Report: TAB Report
Function: Test, Adjust, & Balance
Date: 09/05/2025
Completed By: National TAB

PROJECT
08-25-25 WAWA #6613 CHANTILLY, VA

Project Summary

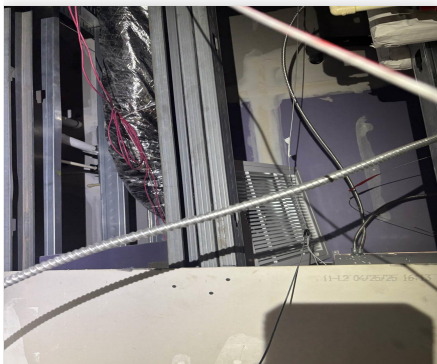
Issue Name : ALL RTU's MIXED AIR COMPARTMENT PLENUM PANEL INSULATION
Description : Insulation is coming loose from inside the mixed air compartment. Recommend re-securing.
Created By : National TAB **Assigned To :** National TAB - Cody Mauro
Status : Open
Priority : High **Asset Tag :**
Originated Date : 08/27/2025 - Cody Mauro - National TAB

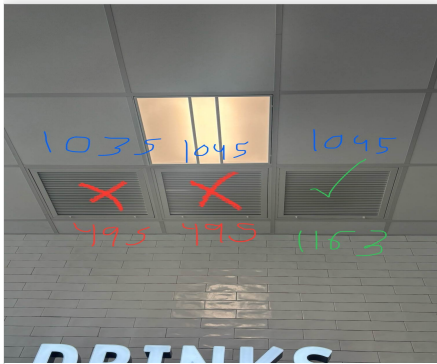
Issue Name : EF2 AIRFLOW LOW
Description : Airflow measured as 869 CFM out of design of 1400 CFM. Design static pressure is 0.25" but the actual static pressure is 0.56" which indicates restriction. Need the mechanical contractor to verify that the balancing dampers are fully open and not closed.
Created By : National TAB **Assigned To :** National TAB - Cody Mauro
Status : Open
Priority : High **Asset Tag :** EF2
Originated Date : 08/28/2025 - Cody Mauro - National TAB

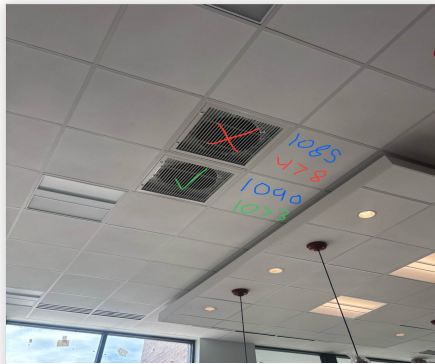
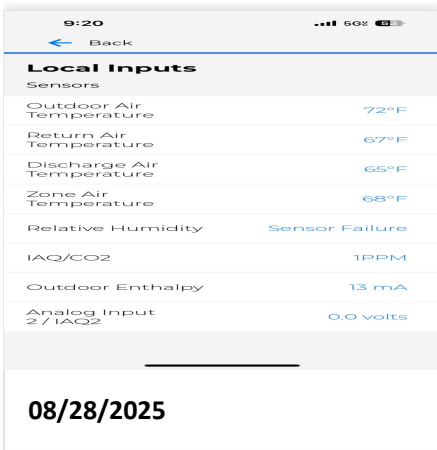
Issue Name : RTU 1 & 3 RETURN DAMPERS
Description : RTU 1 & 3 appear to have closed return dampers. There is elevated static pressure at the units as a result. Need assistance from the mechanical contractor to open the dampers due to the height of the ceiling.
Created By : National TAB **Assigned To :** National TAB - Cody Mauro
Status : Open
Priority : High **Asset Tag :**
Originated Date : 08/28/2025 - Cody Mauro - National TAB

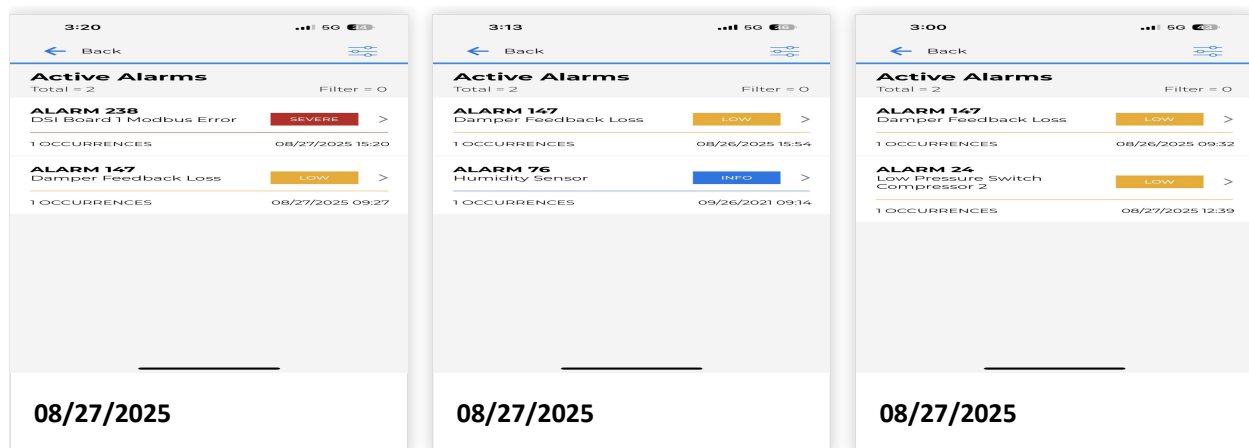
Cannot open panel without insulation getting sucked off. Needs to be resealed

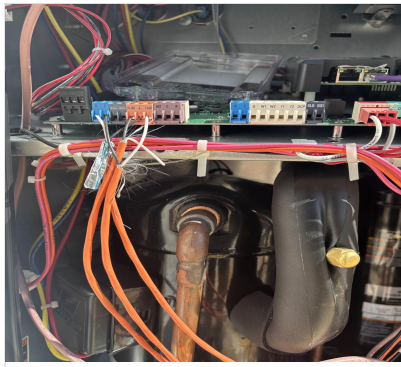
Verify that the CORE or Prodigy controller is sensing a relative humidity (record the reading) Fail

RTU1: 62% RTU2: Sensor Failure RTU3: 55%

Outdoor Air Temperature	72°F
Return Air Temperature	67°F
Discharge Air Temperature	65°F
Zone Air Temperature	68°F
Relative Humidity	Sensor Failure
IAQ/CO2	1PPM
Outdoor Enthalpy	13 mA
Analog Input 2 / IAQ2	0.0 volts

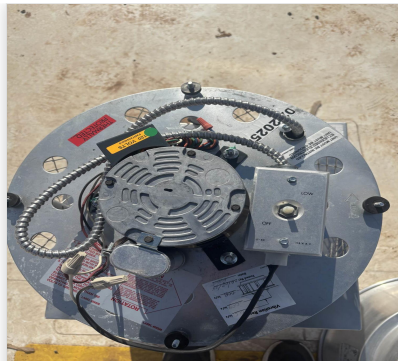
Back draft damper installed and can it fully open?	Fail
---	------

No backdraft damper installed for EF2

Speed controllers for both EF's are maxed, total not within +/-5%. Grilles unable to be balanced due to lack of air.
